<b>BRIEF DESCRIPTION OF REQUEST</b>
Amend approved Site Plan for Building Permit to add in a retail kiosk.

**ADMINISTRATIVE AMENDMENT TO OVERALL SITE PLAN FOR BUILDING PERMIT**

## Administrative Amendment Request

Transportation Development Comments:

---

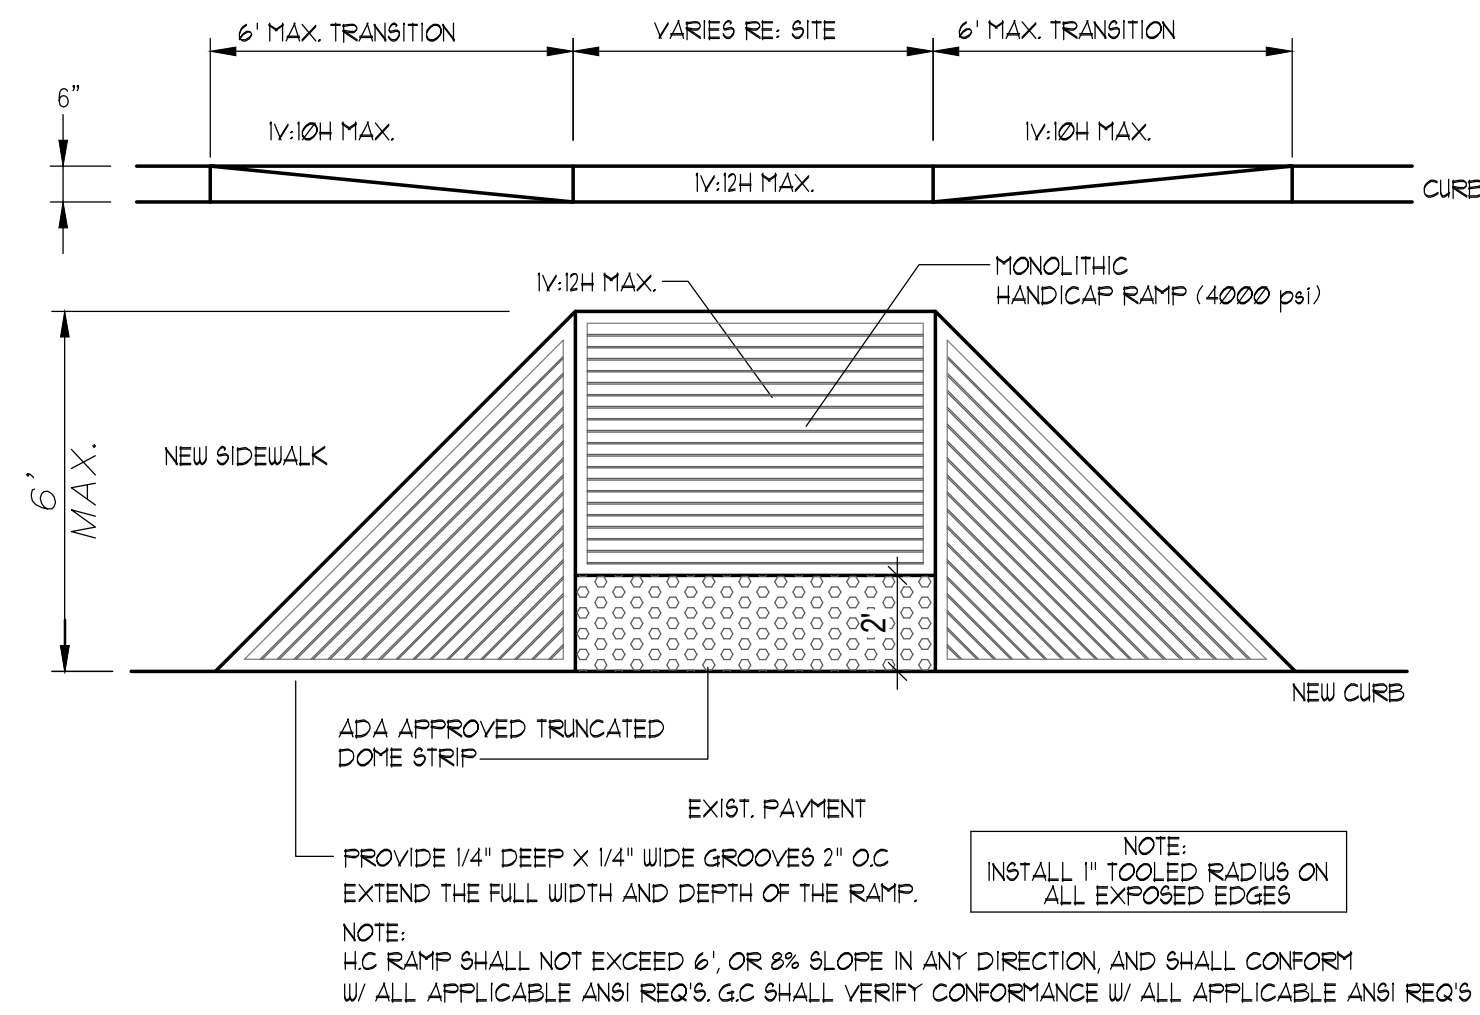
- Please explain why you are proposing concrete stoop and concrete landing.
  - Addressed:
    - The concrete around the kiosk is used to level the asphalt with the kiosk. The kiosk does not fit level on the asphalt.
- Provide details for the proposed concrete landing and concrete stoop.
  - Addressed:
    - Please see details on A-2.
